RE: 150 Steeles Avenue East and 248, 250 & 314 Martin Street, Milton, Proposed Mixed-Use Development

This memorandum is intended to provide additional information to address the Town’s transportation-related comments dated April 2, 2026 and April 8, 2026, and the Region’s transportation comments dated April 17, 2026, in regard to BA Group’s February 2026 Transportation Considerations Report (“the February 2026 BA Group Report”). We trust that the enclosed memorandum provides the appropriate information requested by the Town. Please feel free to let us know if you have any questions or require any additional information.

1.0 BA GROUP RESPONSES TO TOWN COMMENTS

Appendix C: Vehicle Manoeuvring Diagrams

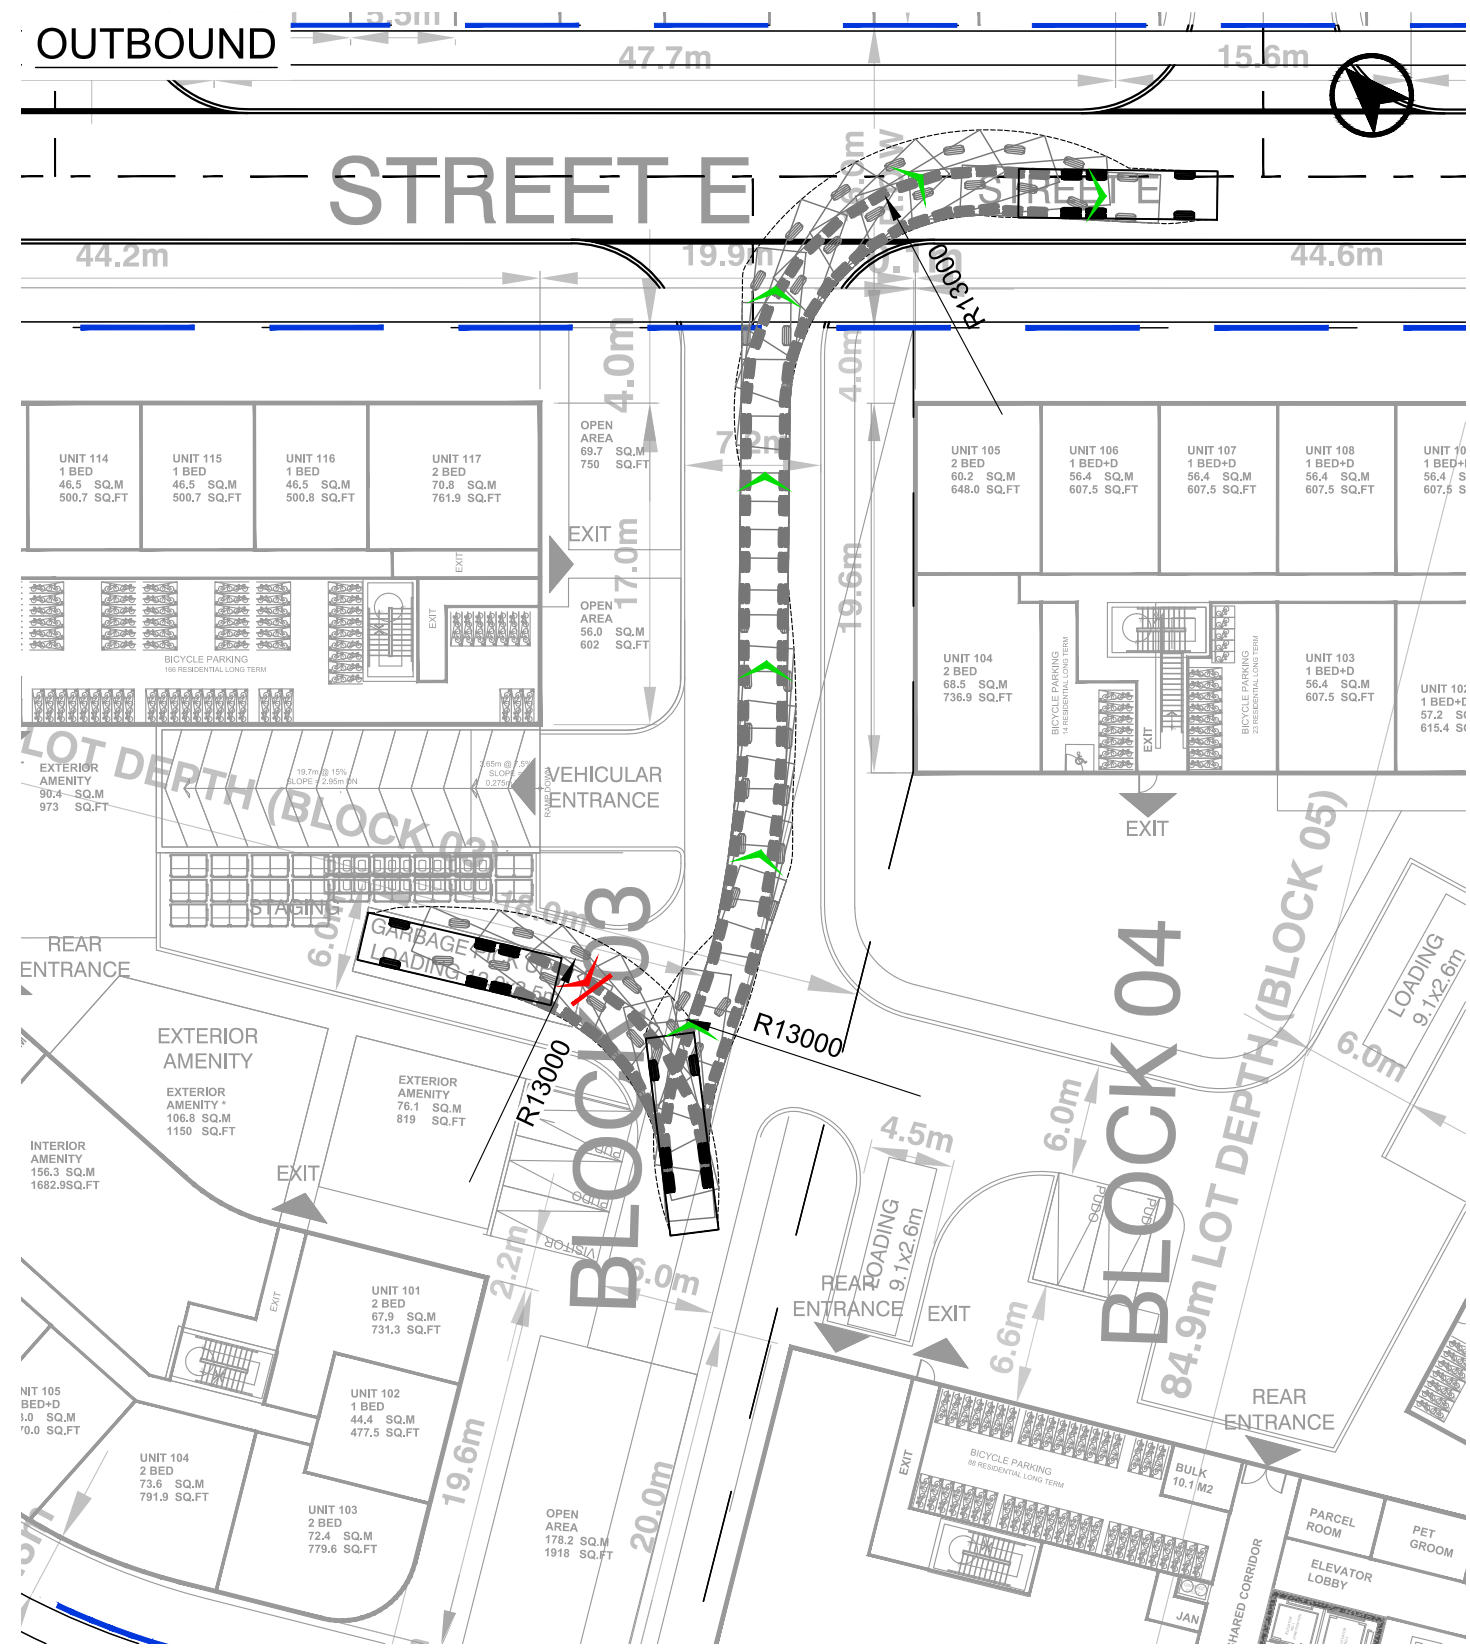
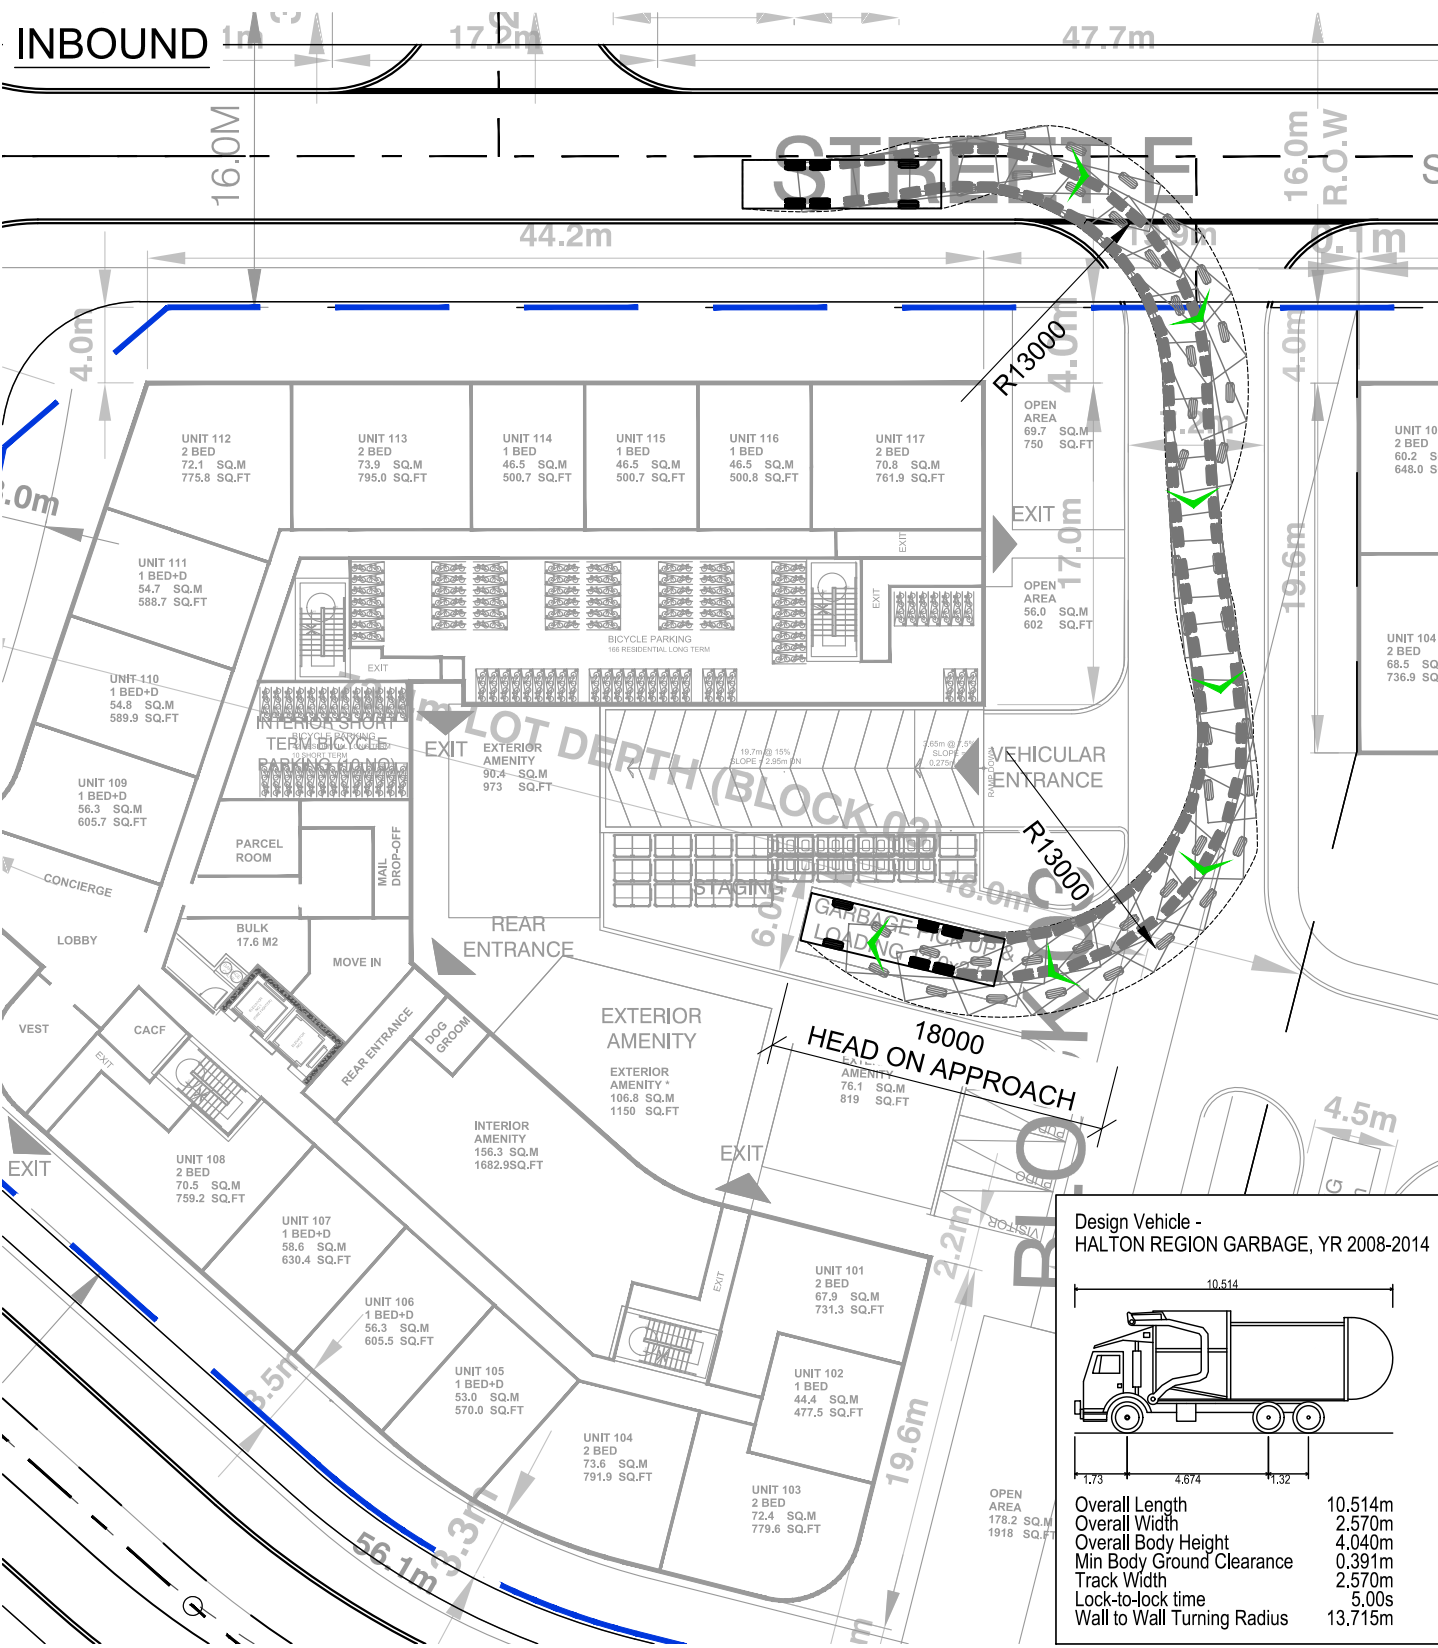
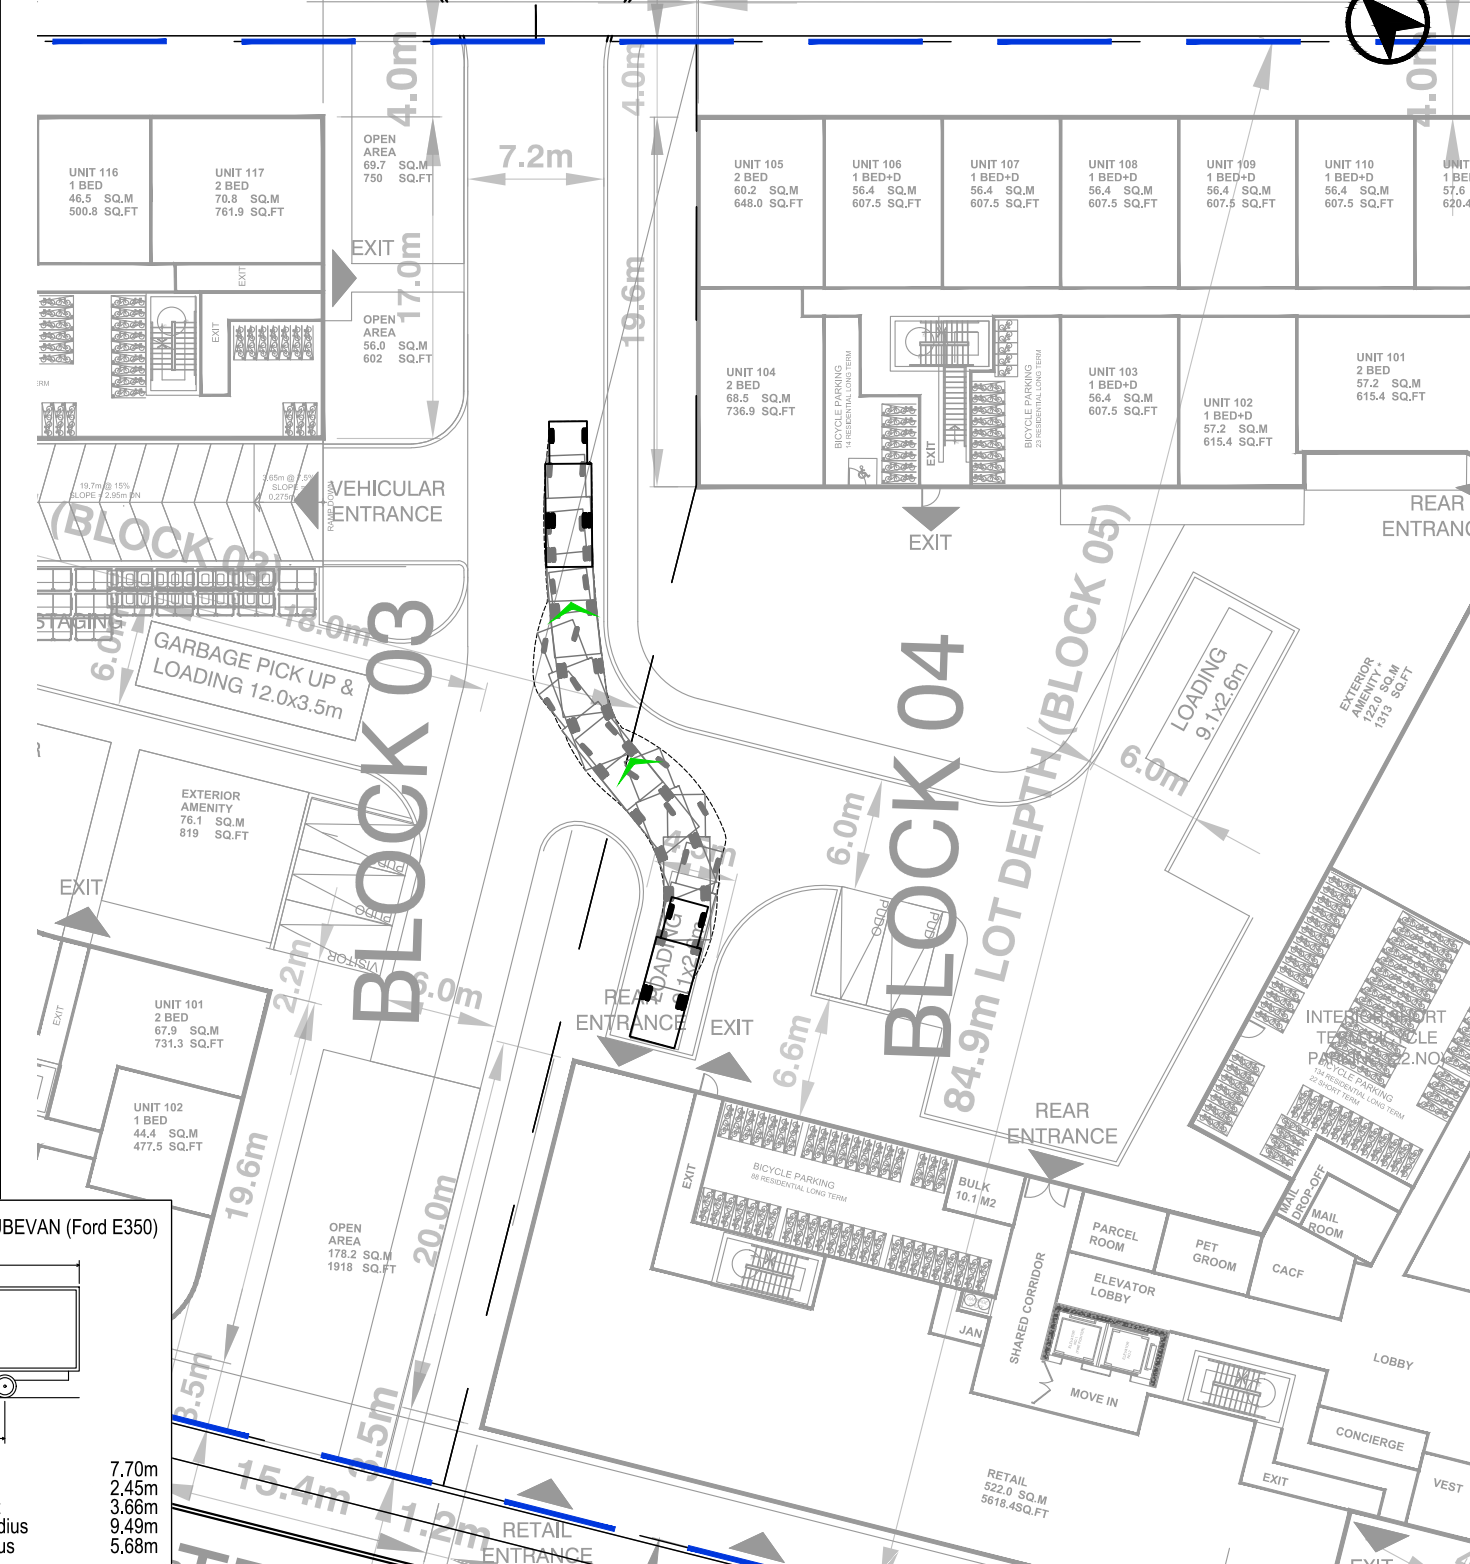
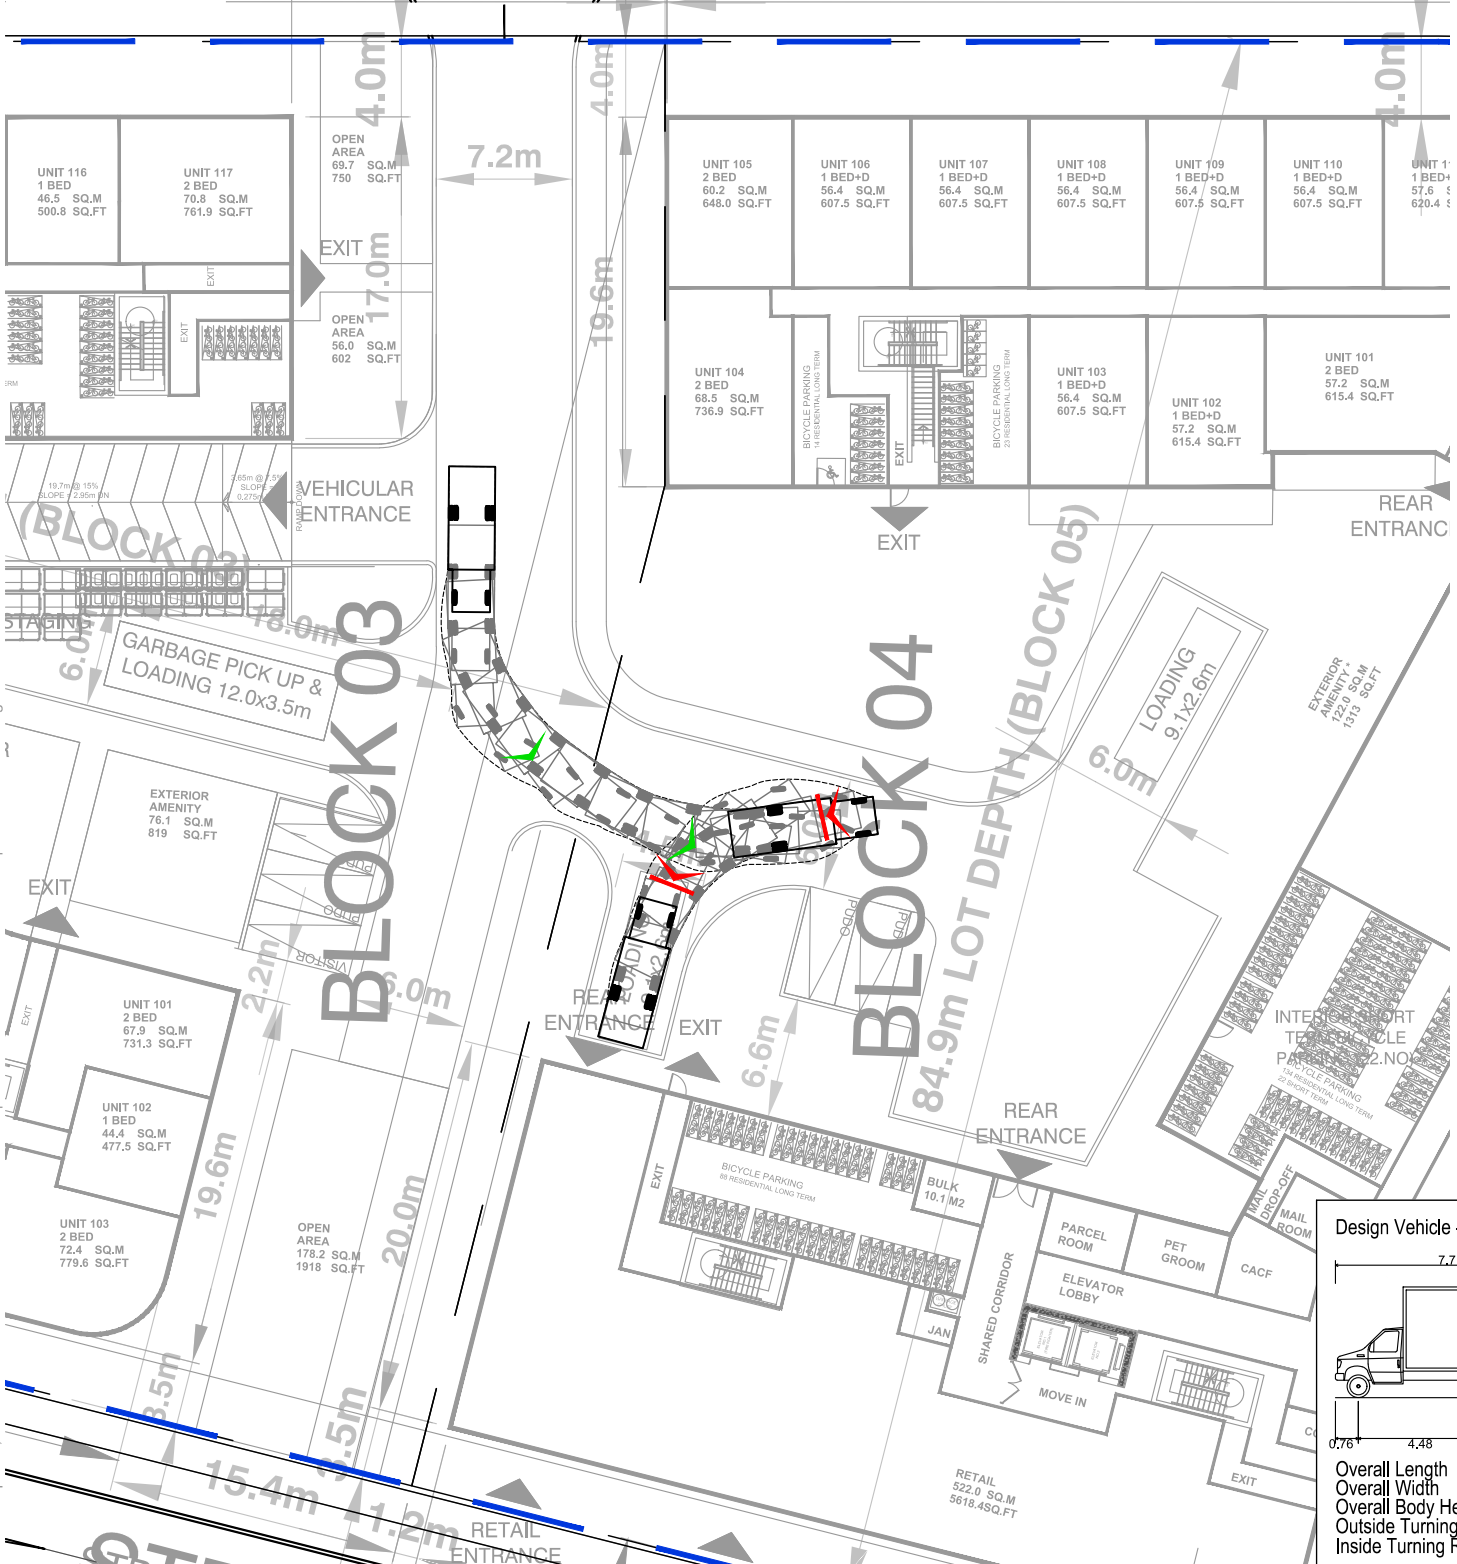
Comment: Please indicate the centreline turning radius in all locations where the waste collection vehicle is turning and approaching loading area (minimum 13 metres).

Comment: Please indicate the length of the head-on approach (minimum 18 metres).

Comment: Please indicate the distance the waste collection vehicle will be required to reverse (maximum 18 metres).

Comment: Please indicate the waste collection vehicle route from the municipal road to the Collection Point and back to the municipal road. Please ensure to include the turning radius of all turns.

Comment: Where continuous forward movement of waste truck cannot be achieved, a cul-de-sac or T-turnaround may be permitted if 13m turning radius and max 18 metre backup distances can be met.

Comment: Notwithstanding the loading requirements set out in the Town 's Zoning By-law, the loading spaces in Phase 1 of the development are proposed to be 12 m x 3.5 m (overhead waste collection) in size.

- All dimensions on the below loading areas including centre line turning radii.
- One truck maneuvering diagram. The overlay provided below makes it difficult to determine the path of the collection vehicle.

Response: The centreline turning radius of a minimum of 13 metres is illustrated on the Vehicle Manoeuvring Diagrams (VMDs) attached in **Appendix C**.

Response: The 18 metres head-on approach is illustrated on the VMDs attached in **Appendix C**.

Response: The reversal distance of the waste collection vehicle is illustrated on the VMDs attached in **Appendix C** and illustrate reversal distances of 18 metres or less.

Response: VMDs provided in **Appendix C** illustrate waste collection vehicles entering each block from the municipal road and leaving each block onto the municipal road.

Response: VMDs provided in **Appendix C** illustrate waste collection vehicles entering and existing each site in a forward motion. The turning radius (minimum 13 metres) and the reversal distances (maximum 18 metres) are illustrated on the VMDs.

Response: Vehicle Manoeuvring Diagrams provided in **Appendix C** illustrate the waste collection vehicle entering and exiting the proposed waste collection areas with dimensions (minimum 13 metres turning radius, minimum 18 metres head-on approach and maximum 18 metres reversal distance).
